**Pilot Operating Handbook and Aircraft Flight Manual**  
**Viking DHC-6 Series 400 (Twin Otter) and Variants,**  
**PSM 1-64-1A, Revision 3,**  
**dated 8 Feb. 2017**

**Limited Review<sup>1</sup>**

Harry Horlings<sup>2</sup>, *AvioConsult*, Flight Test Engineer, 2025-12-18

Figure 4-1 Rotation Speeds

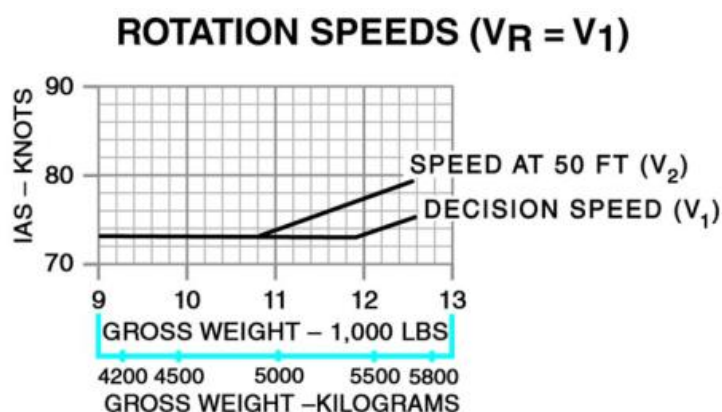
6.1.2. FAR 23.51(c)(2) requires  $V_R$  to be  $V_1$ ,  $1.05 V_{MCA}$ ,  $1.10 V_{S1}$ , or the speed that allows attaining  $V_2$  before reaching 35 ft above the takeoff surface, whichever is greater.

- At 10,000 lb gross weight,  $V_S = 61$  KCAS = 63 KIAS (The difference between  $V_S$  as CAS and IAS at maximum weight is 2 kt – Table 5-3 and Figure 5-6, with instrument error zero).  
 $V_R = \text{highest of } 1.05 \times 64 (= 67) \text{ and } 1.10 \times 63 (= 69) = 69 \text{ KIAS.}$   
 However, if the wings are kept level, actual  $V_{MCA}$  is 6 kt higher. Then  $V_R = \text{highest of } 1.05 \times 70 (= 74) \text{ and } 1.10 \times 63 (= 69) = 74 \text{ KIAS.}$
- At maximum weight,  $V_S = 68$  KCAS = 70 KIAS (with zero instrument error), then  
 $V_R = \text{highest of } 1.05 \times 64 (= 67) \text{ and } 1.10 \times 70 (= 77) = 77 \text{ KIAS.}$
